Register Reference Number: S25421/22

RE: Vantage Towers Ltd application for Licence under Section 254 of the Planning & Development Act (as amended) for a 15m high telecommunications street-work structure at Scholarstown Road, Scholarstown, Co. Dublin.

Further to your letter dated 7th March 2022 requesting further information in respect of the above application please find responses answering each question in turn as follows;

Figure 1; ComReg map of existing sites within 2km radius

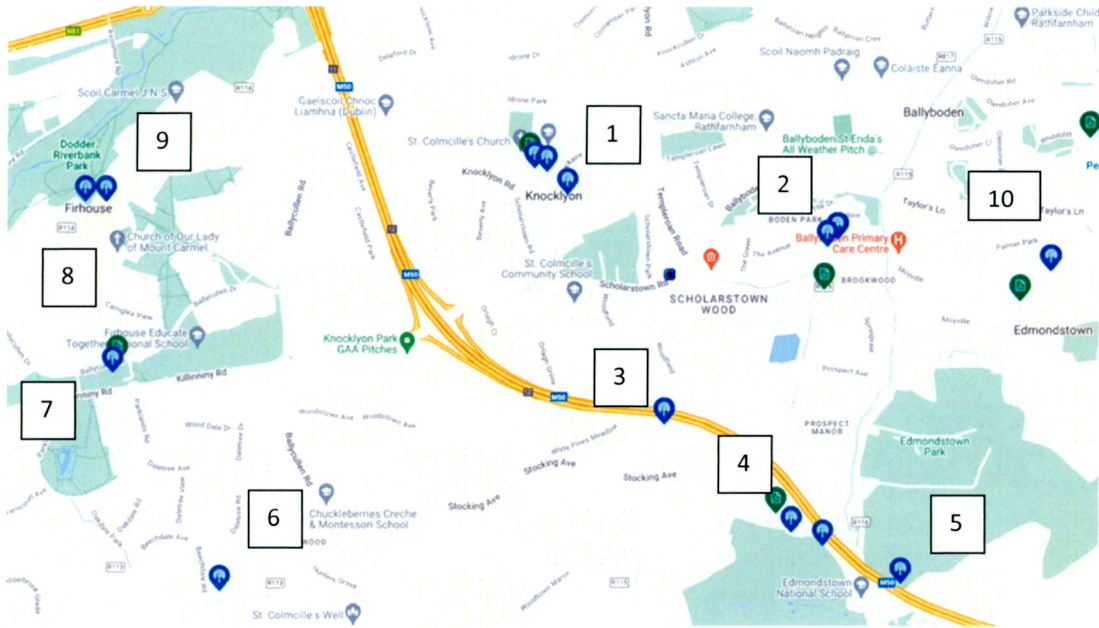
- I. **A coverage map with existing and proposed coverage.**
- II. **A Comreg map showing existing sites in the general area and a list of established sites within a 2km radius.**
- III. **A Visual Impact Assessment**

ComReg operates 'site viewer', a geo-website, which identifies existing communication sites. The map above illustrates the structures within a 2km radius of the application site.

1. Supervalu Knocklyon: Vodafone, Meteor and Three Ireland currently transmit from antennas from the roof of the Supervalu in Knocklyon, approximately 390m north of the application site. As Vodafone are already present, further Vodafone equipment would not address the coverage issues in the target area. As a result, this site has been discounted.

2. Eir Exchange, Scholarstown Road: Vodafone and Meteor currently transmit from a 21.5m high lattice structure on the grounds of an eir exchange approximately 1.2km east of the application site. As Vodafone is already present here, further Vodafone equipment would not address the coverage issues in the target area. As a result, this structure has been discounted.

3. Green Acres House: Vodafone, Meteor and Three Ireland currently transmit from a 15m high monopole, approximately 750m south-east of the application site. As Vodafone is already present, further Vodafone equipment would not address the coverage issues in the target area. As result, this structure has been discounted.

4. Rathfarnham Golf Club: There are two structures located on the grounds of Rathfarnham Golf Club, approximately 1.3km from the application site. Vodafone transmit from a 24m high structure while Meteor transmit from a 20m structure. As Vodafone is already present here, further Vodafone equipment would not address the coverage issues in the target area. As a result, this structure has been discounted.

5. Edmondstown Golf Course: Three Ireland currently transmit from a 10m high timber pole located on the grounds of Edmondstown Golf Course. 10m is too low to allow Vodafone to achieve its technical objectives for the target area. The site is also located approximately 1.7km from the application site which is too far. As a result, this structure must be discounted.

6. Hunters Road: eir currently transmit from a street works structure located approximately 1.6km south-west of the application site. Street works structures are not designed for site sharing. As a result, this structure must be discounted.

7. Scholars Pub: eir currently transmit from antennae placed on the side of Scholars Pub, approximately 1.8km from the application site. This distance is too far for Vodafone to achieve its coverage objectives in the target area. As a result, this structure has been discounted.

8. Firhouse Community & Leisure Club: Vodafone currently transmit from the rooftop of a Firhouse Community & Leisure Club approximately 1.6km west of the application site. As Vodafone is already present, placing further equipment at this location would not achieve the technical objectives for the target area. As a result, this structure has been discounted.

9. Speaker Connolly: Three Ireland and Vodafone currently transmit from antennae located on the rooftop of the Speaker Connolly pub located approximately 1.6km north-west of the application site. As Vodafone is already present, placing further equipment at this location would not achieve the technical objectives for the target area. As a result, this structure has been discounted.

10. Pearse Brothers Park: eir, Three Ireland and Vodafone currently transmit from a lattice structure located 1.9km east of the application site. As Vodafone is already present, placing further equipment at this location would not achieve the technical objectives for the target area. As a result, this structure has been discounted.
